PRODUCT CHANGE NOTICE PCN Form (D4-E000-73)

PCN#18-047

ROS-3000-619+

Surface Mount Voltage Controlled Oscillator

Performance Data & Curves*

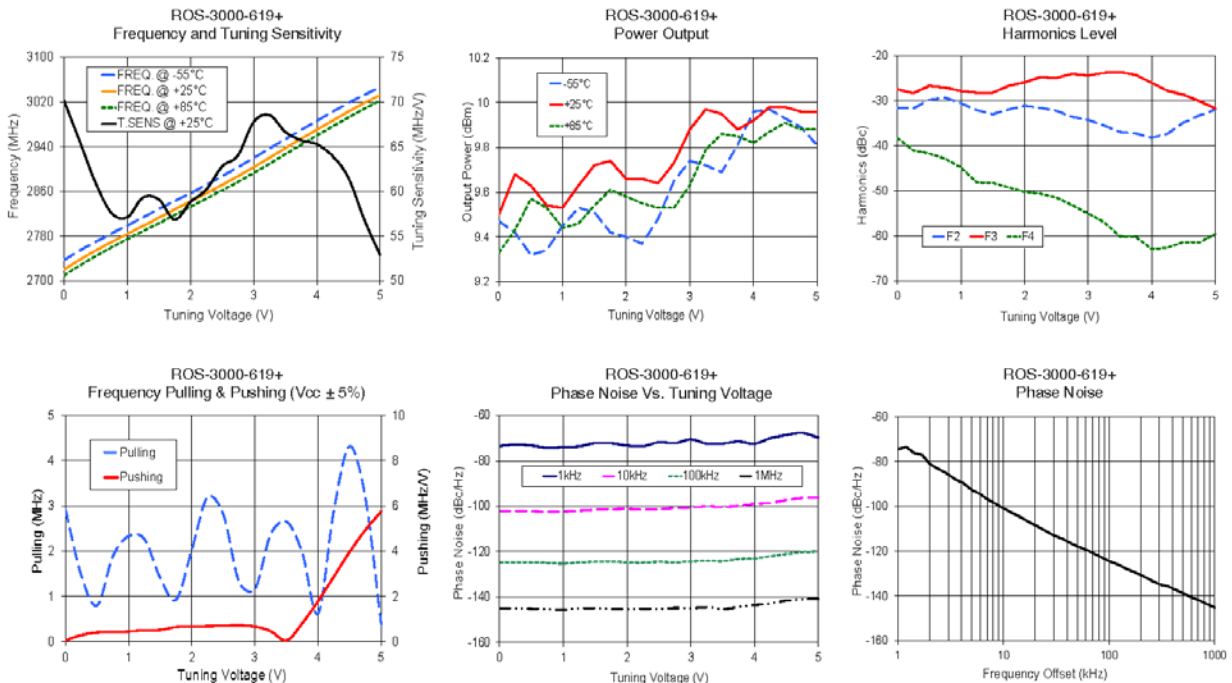
1. Replacement of supplied transistor and varactor diode based on discontinuation of supply with alternate, qualified components.
2. Change of internal component values to optimize replacement parts

No change in FIT or FORM, shift in performance per table below:

Parameters	Original Performance	New Performance
DC Current	28.4 to 28.6 mA	30.7 to 31.1 mA
2nd Harmonic	-24.29 to -20.35 dBc	-38.95 to -30.46 dBc
3rd Harmonic	-38.79 to -27.64 dBc	-32.5 to -21.66 dBc

Data available to support the change
See updated datasheets below for change in performance.
